R44 SERVICE BULLETIN SB-105

SUBJECT: Alternator Filter Installation

EFFECTIVITY: R44 helicopters factory-equipped with Automatic Direction Finder (ADF) equipment and R44 Police version helicopters.

FIGURE 1 REFERENCE VIEW OF EXISTING AK 950-FTR FILTER

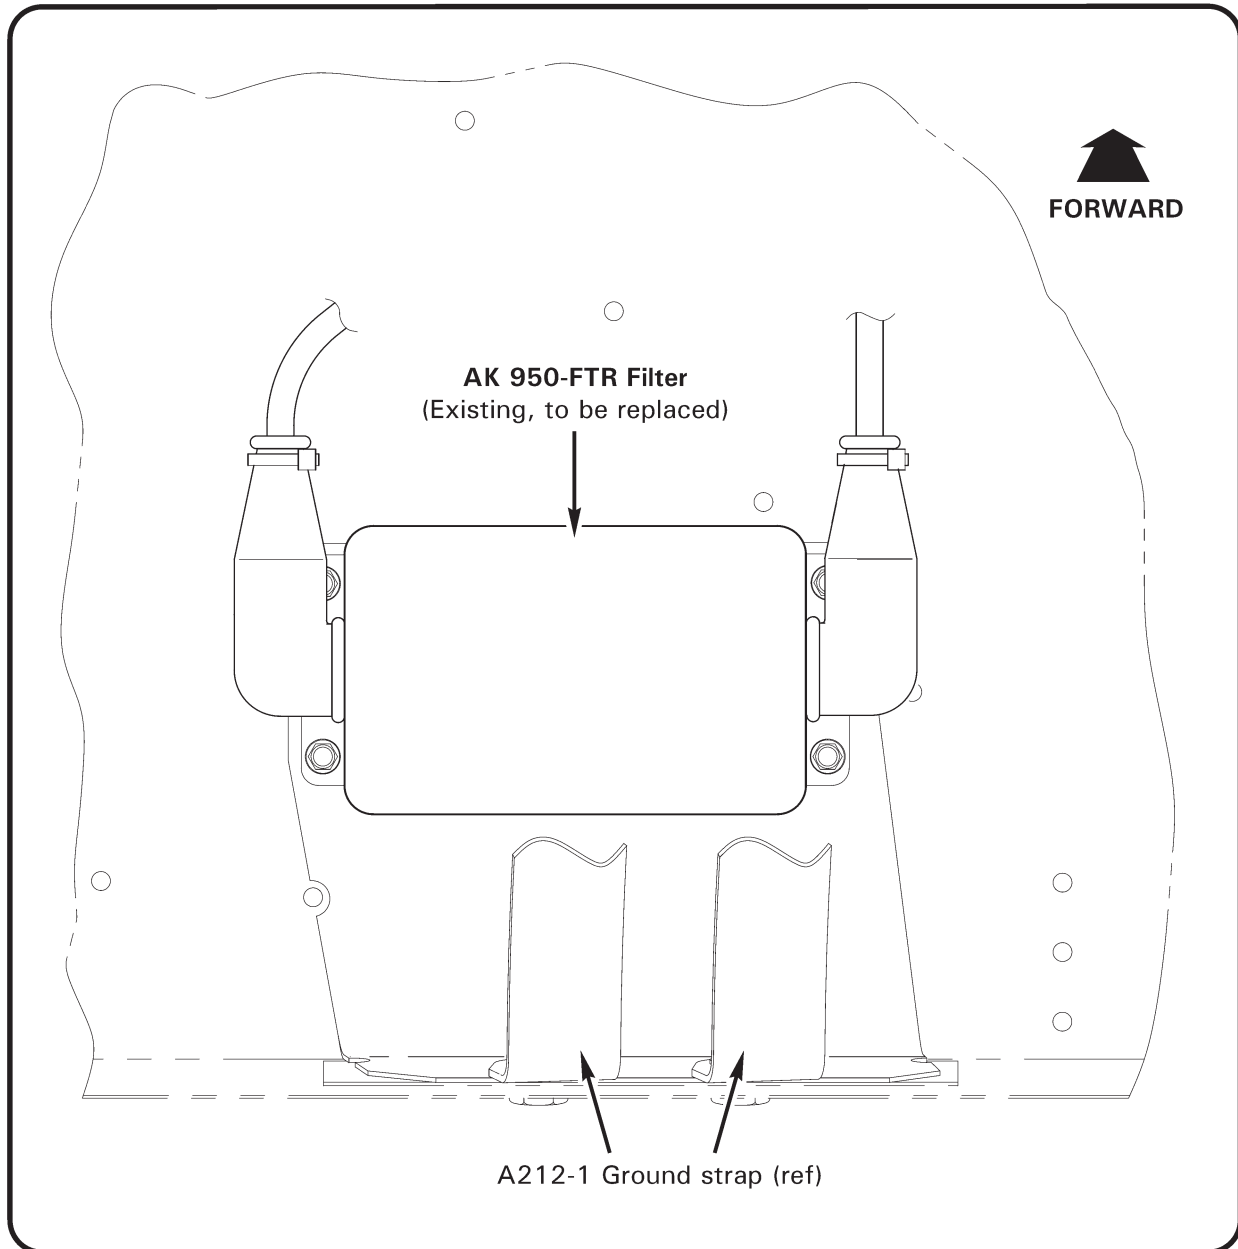
1. Refer to Figure 1. Open left engine inspection cowl door, and determine whether an AK 950-FTR filter is installed (mounted to vertical firewall).
2. If an AK 950-FTR filter is installed, order one KI-273 RFI Filter Replacement Kit.
3. Install KI-273 Kit per kit instructions.
4. Make appropriate maintenance record entries.
